LOUISIANA
POWER & LIGHT

SUBJECT: Waterford SES Unit 3
Docket No. 50-382
Auxiliary Pressurizer Spray (APS)

WATERFORD 3
Justification for Interim Operation
Auxiliary Pressurizer Spray

FIGURE 1

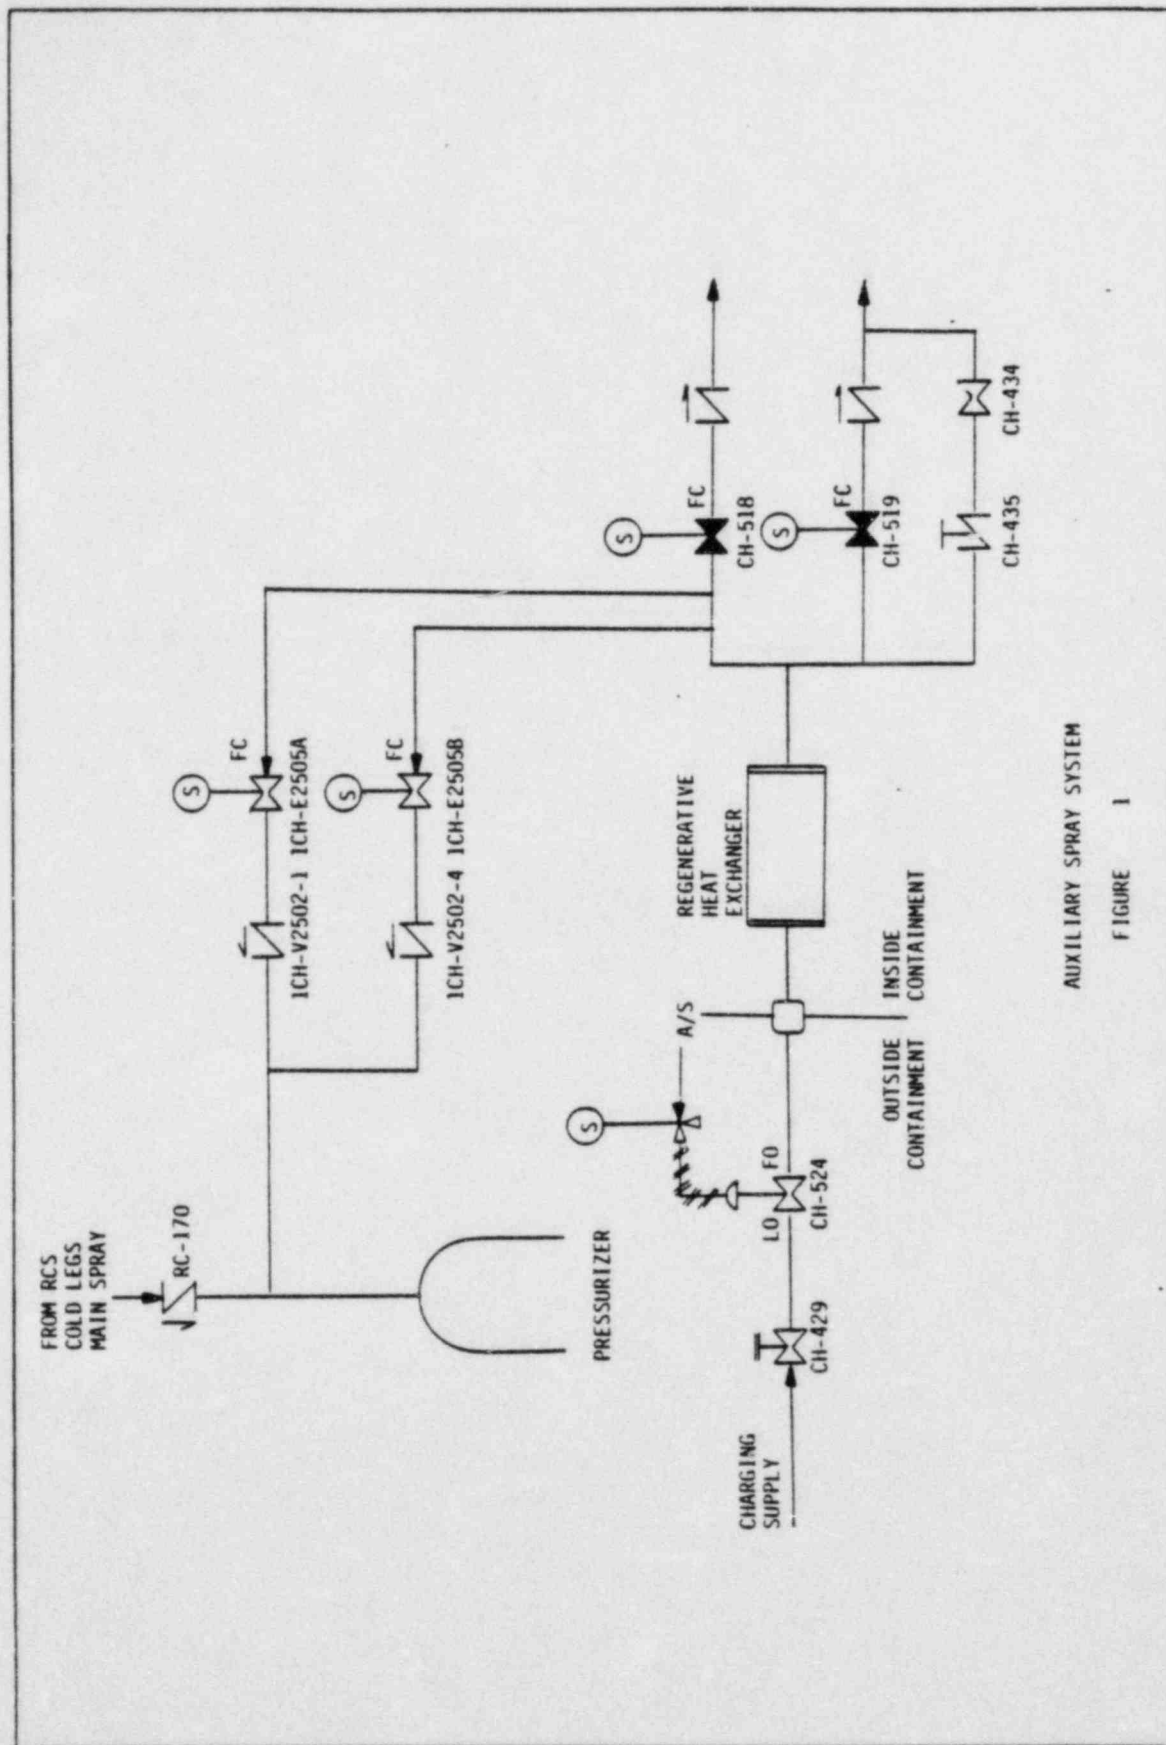
The NRC has expressed a concern that the APS depressurization may potentially be defeated if one of the two charging line isolation valves (CH-518 or CH-519, see Figure 1) fail to close. This will cause a diversion of flow from the pressurizer spray nozzle and a reduced depressurization rate. Justification for safe full power operation of Waterford 3 prior to final resolution of this concern is based on the following considerations:

The charging line isolation valves (CH-518 and CH-519 in the attached figure) are solenoid valves controlled by the operator from the control room. The failure probability of these valves has been evaluated in CEN-239, Supplement 2, "Probabalistic Risk Assessment of the Effect of PORVs on depressurization and Decay Heat Removal", submitted to the NRC by Reference 1. The probability for either charging line isolation valve to fail to close due to a mechanical malfunction is approximately $2.3E-3$. Thus the probability that the effectiveness of the APS will be reduced because these valves fail to close is very low.

Finally, preliminary calculations have been performed to calculate the flow delivered to the pressurizer spray nozzles with an open charging line isolation valve. These calculations account for the hydraulic resistance and elevation differences in each flow path (charging and spray) to determine the percent flow split between the two paths. Based on these preliminary calculations, one-quarter of the APS flow achieved with both charging valves closed goes to the pressurizer spray nozzles. Although this would result in a reduced depressurization rate relative to the full APS flow capability, it should be sufficient to mitigate the consequences of a SGTR.

In conclusion, Waterford 3 can be operated safely through the end of the first cycle based on the above considerations. This includes the extremely low probability of a SGTR occurring with a concurrent failure of one of the charging line isolation valves to close, the use of alternate methods (pressurizer vent

and throttling HPSI pumps) to depressurize the RCS during a SGTR while maintaining subcooling margin requirements, and preliminary calculations which show that a portion of the flow (one-quarter of the APS flow with no failure) reaches the pressurizer spray nozzles even if a charging line isolation valve fails to close.
